**Analysis of US Department of Energy Record of Decision
Onsite Disposal Alternative
Environmental Management Disposal Facility
Site 7c
Central Bear Creek Valley
For
The City of Oak Ridge, TN**

Kalbacher Associates, LLC

October 2021

Figure 8. Typical cross section of EMDF.

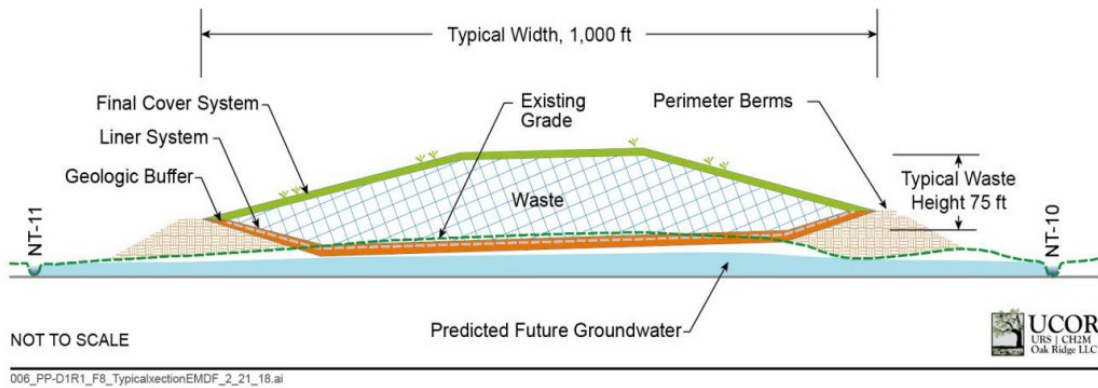
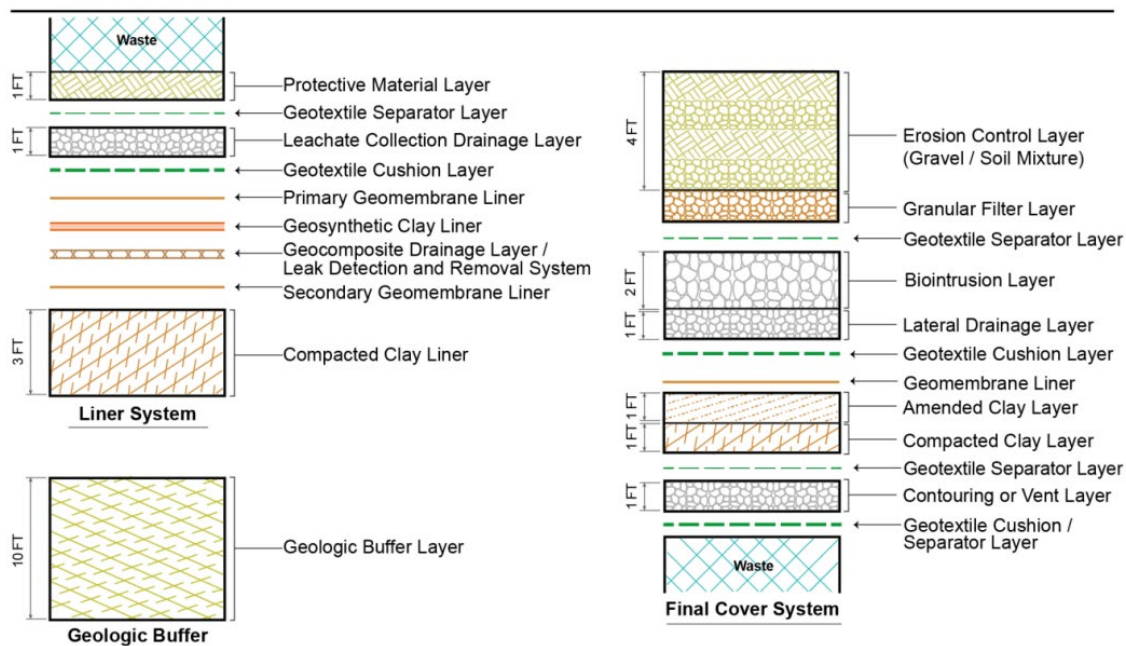
- DOE will construct and operate a landfill wastewater treatment system (LWTS) consistent with ARARs. However, the ROD does not present a definite plan to build wastewater treatment and interim storage facilities at EMDF. Neither does the plan discuss anticipated volumes, contaminants, discharge limits, storage capacity needs, or cost estimates. Definitive, long-term wastewater management plans should be included for public review.
